Subject: Exelon Nuclear Texas Holdings, LLC  
Victoria County Station Early Site Permit Application  
Response to Request for Additional Information Letter No. 07  
NRC Docket No. 52-042

Attached are responses to NRC staff questions included in Request for Additional Information (RAI) Letter No. 07, dated April 8, 2011, related to Early Site Permit Application (ESPA), Part 2, Sections 02.04.06, 02.05.02, and 11.02. NRC RAI Letter No. 07 contained twenty Questions. This submittal comprises a partial response to RAI Letter No. 07, and includes responses to the following seven Questions:

Figure 1. Dimensions of East Breaks slump scar. Source of data: NGDC (2008) (Reference 6).

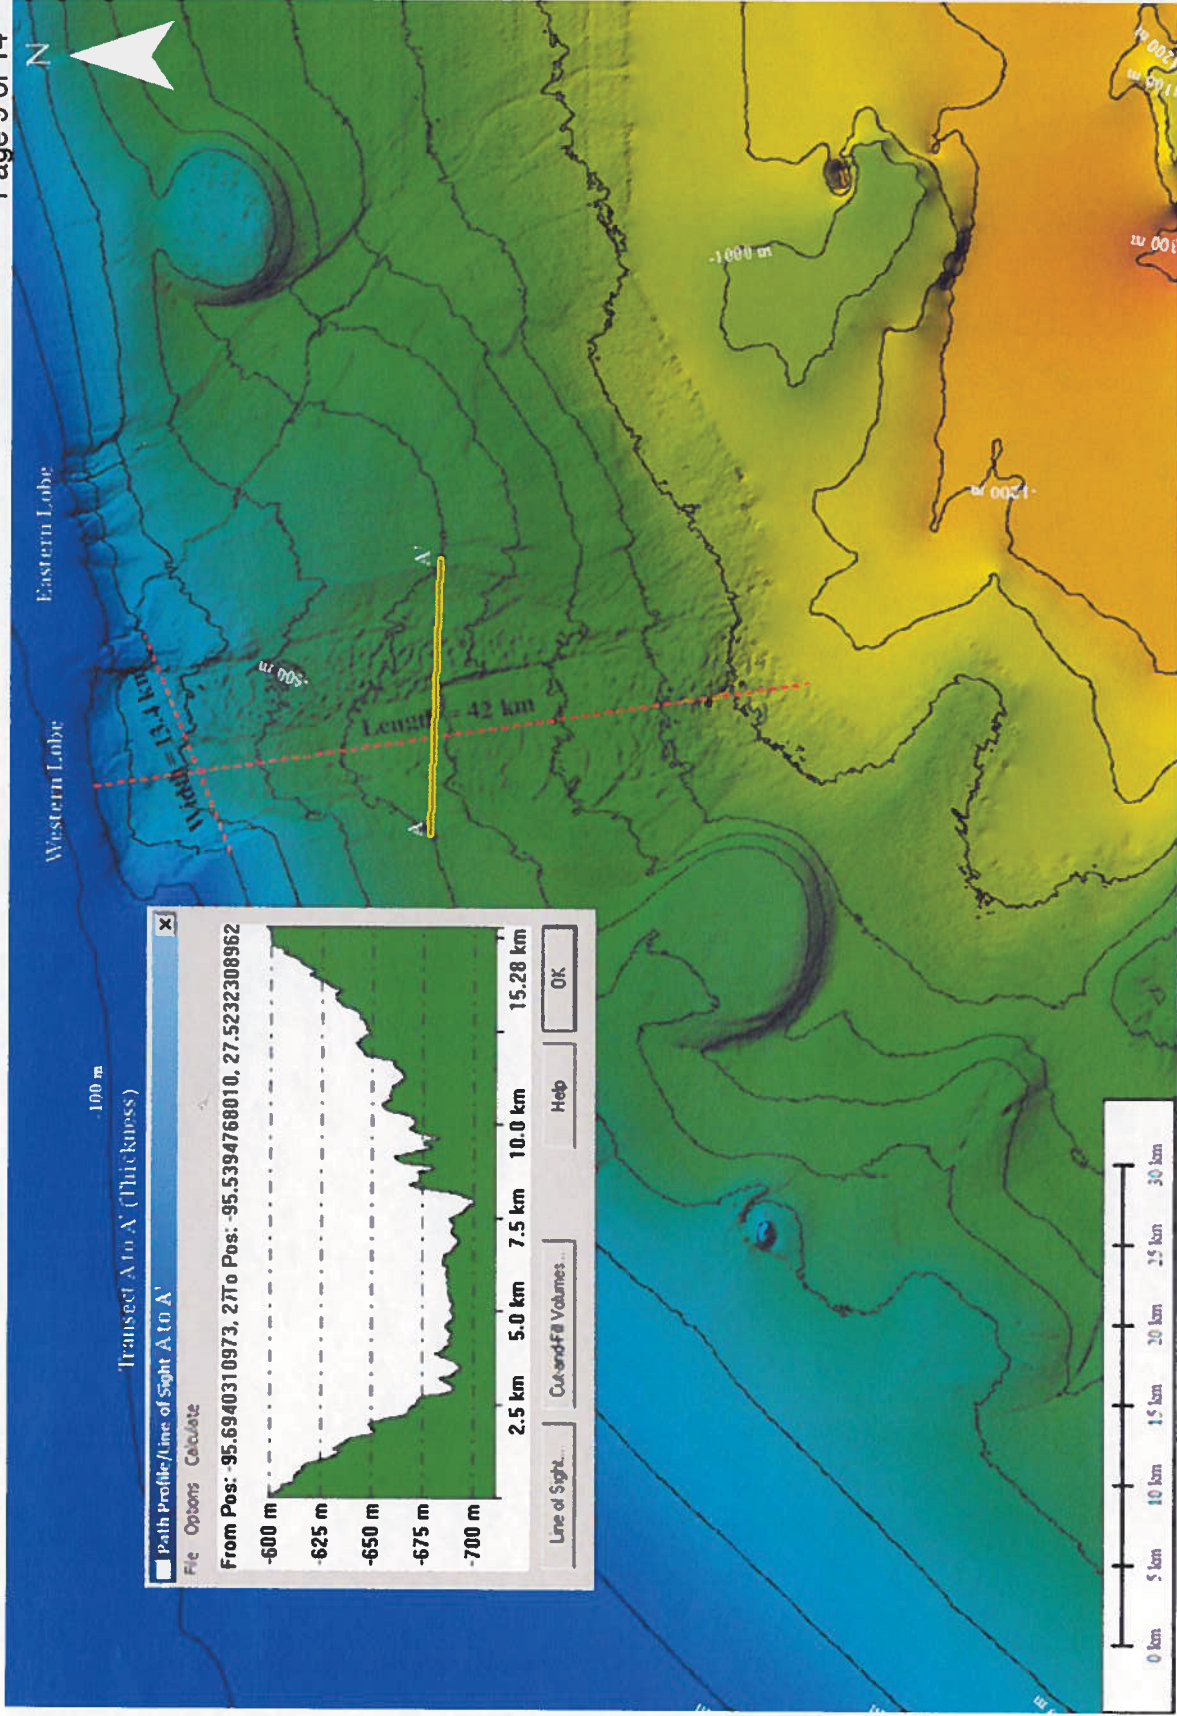
- (6) Updated information, using recently published sources or independent evaluation, on the tsunami source parameters used for the East Breaks slump.

Estimates of dimensions of the East Breaks slump scar have varied with different investigations. For example, source parameters for the East Breaks slump scar are provided in Reference 1. Source parameters for the East Breaks slump were also estimated independently from three-arc-second bathymetry data from the National Geophysical Data Center (NGDC) (Reference 7). Slump width was estimated to be approximately 13.4 km (Figure 1). The length of the erosional chute was estimated to be about 42 km. Based on a transect across the erosional chute, slump thickness was estimated to be about 100 m (i.e., see cross-section profile A to A' in Figure 1). With respect to slope, SSAR Reference 2.4.6-3 stated that "initial failure of the slump took place on very low angle slopes of less than two degrees while present slump deposits have an average seafloor slope of one-degree." While a vertical drop of 850 m over a length of 42 km indicates a bed slope of approximately 1.1 degrees, a maximum local slope of 2 degrees was used as a conservative estimate. Similarly, initial depth of the slide was estimated conservatively at the depth of the midpoint between the 200-m and 1000-m bathymetry contour elevations. Therefore, initial depth was estimated to be 600 m (i.e.,  $(200 \text{ m} + 1000 \text{ m})/2$ ). Reference 1, citing interpretation of side-scan sonar data by Reference 8, estimated the length of the East Breaks slump as 114 km. Therefore, the total slide length was assumed to be 114 km.

Figure 1. Comparison of the updated seismicity catalog and the PDE catalog

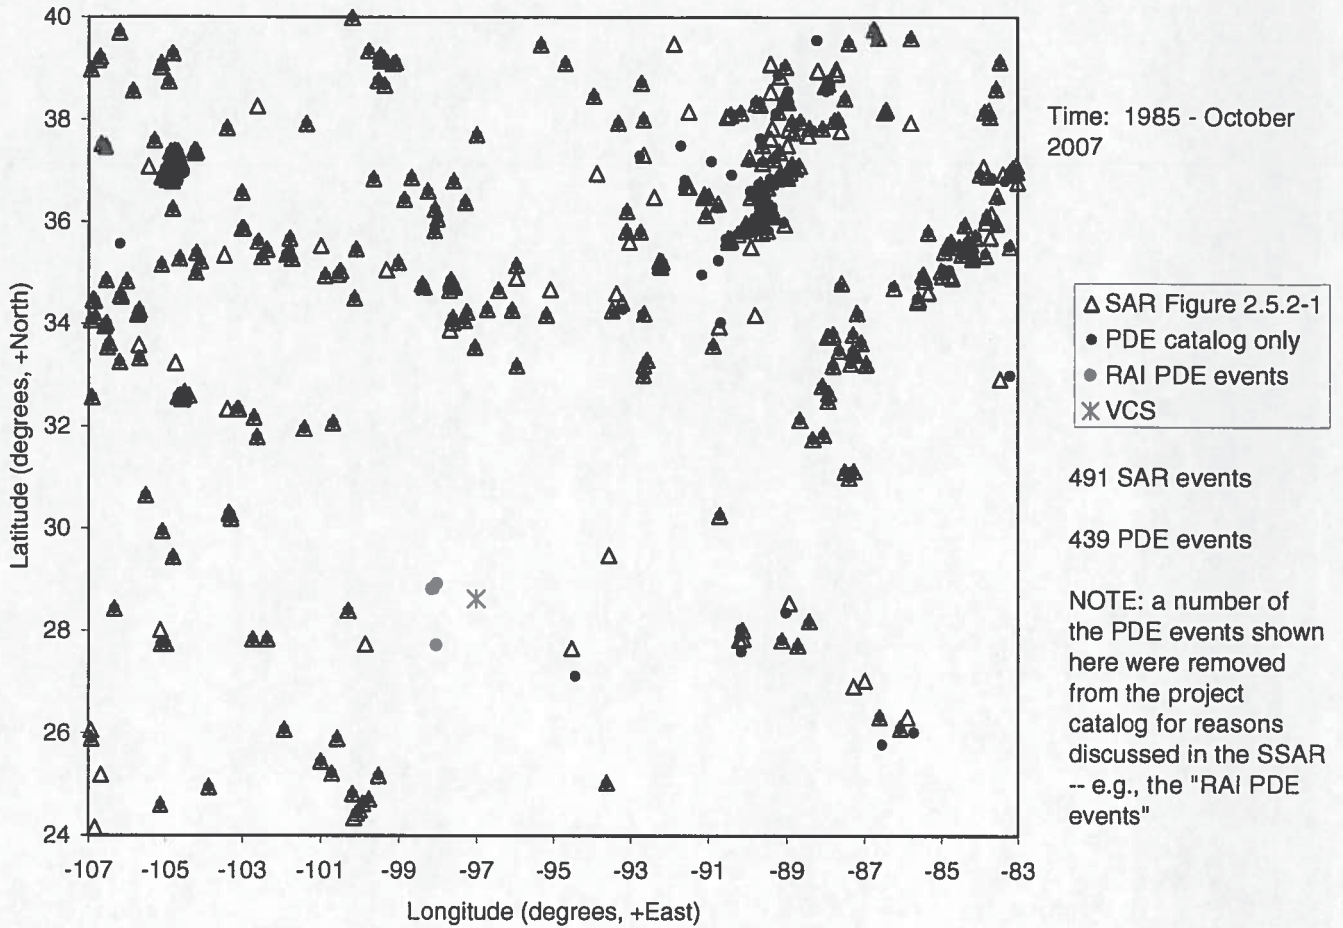
- a) The following four earthquakes are reported by the USGS PDE earthquake catalog and occur within 320-km (200-mi) of the VCS site. These four earthquakes do not appear in the applicant's updated seismicity catalog in SSAR Table 2.5.2-3.

PDE 1991	0720233819.2	28.91	-98.04	10	3.40LgTUL	3.60LgGS
PDE 1993	0409122919.1	28.81	-98.12	5		4.30LgGS
PDE 1993	0516153019.3	28.81	-98.17	5		3.00LgGS
PDE 1997	0324223134.5	27.72	-98.05	5		3.80LgGS

In addition, SSAR Figure 2.5.2-1 appears to show fewer events than a plot of the PDE events within the same investigation window.

Please discuss these apparent discrepancies between the applicant's updated seismicity catalog and USGS PDE catalog and the impact on hazard at the VCS site.

Using the PDE (NEIC) catalog obtained to update the seismicity catalog for the SSAR in 2007, and processing the PDE type-specific magnitudes to obtain Emb -- as discussed in the SSAR -- for the same geographic window (83° to 107°W, 24° to 40°N), magnitudes (Emb ≥ 3.0), and primary update period (1985 – 2007), the resulting PDE seismicity is shown in Figure 1, below.} Figure 1 indicates that there are actually more earthquakes in the SSAR Figure 2.5.2-1 (491 events) than given by the PDE catalog alone (439 events) under the search parameters identified above. (Note that only the explicit Gulf of Mexico area (24°N to 32°N, 100°W to 83°W) was updated for all time, as discussed in the SSAR, and six additional pre-1985 events for the Gulf of Mexico area are tabulated in SSAR Table 2.5.2-2.)

As discussed above, it appears that SSAR Figure 2.5.2-1 shows more earthquakes than given by the PDE (NEIC) catalog alone. It is noted that the PDE catalog was considered in the development of the updated seismicity catalog along with several other catalogs that had events not given in the PDE catalog. Based on processing for priority catalogs in the event of multi-source catalog duplication, as well as removing events assessed to be man-made – including the four PDE events highlighted in this RAI, Exelon concludes there is no discrepancy between the PDE and SSAR seismicity catalogs; therefore, there is no impact on the hazard for the VCS site.

Note: The four red PDE events are the events referred to in the RAI, which have been identified as man-made.

Figure 1. Comparison of HF and LF rock spectra for  $10^{-4}$  where the LF spectrum is only anchored to the low frequency ground-motion values. Note that this LF spectrum was not recommended and used in the site response analysis.

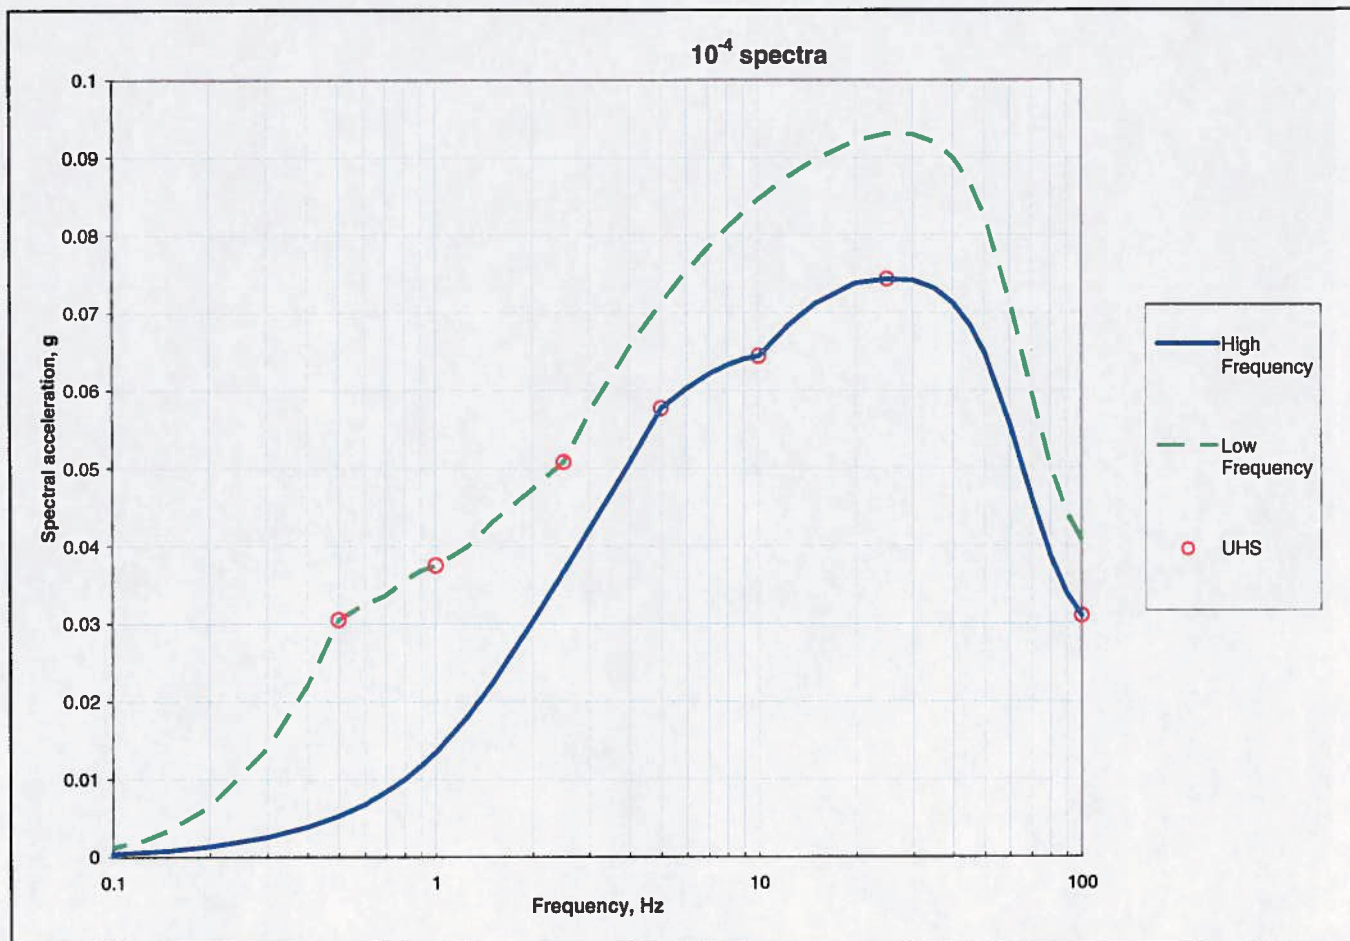
SSAR Section 2.5.2.4.7 describes how the applicant developed its low-frequency (LF) and high-frequency (HF) Uniform Hazard Spectral (UHS) shapes. Please explain the methodology used by the applicant to develop the smooth UHS. In addition, explain why the LF spectrum might exceed the HF spectrum at high frequencies and why this was not allowed.

The results are shown in Figure 1 for the  $10^{-4}$  mean HF and LF spectral case. The LF spectrum in this figure clearly predicts higher ground motions for the high frequency range between 5 Hz and 100 Hz when the spectrum is only anchored to the low frequency ground-motion values. However, based on the HF and LF rock spectra being used as input ground-motion spectra for the development of site amplification factors (SAF), the LF spectrum was anchored to all of the seven ground-motion frequencies used in the hazard.

Finally, it should be noted that uncritical acceptance of extrapolated LF spectral shape to high frequencies, and the consequent increase of the high frequency part of the spectra beyond UHS values developed from the PSHA analysis could overdrive the soil column during the site response analysis, which could lead to lower site amplification factors.
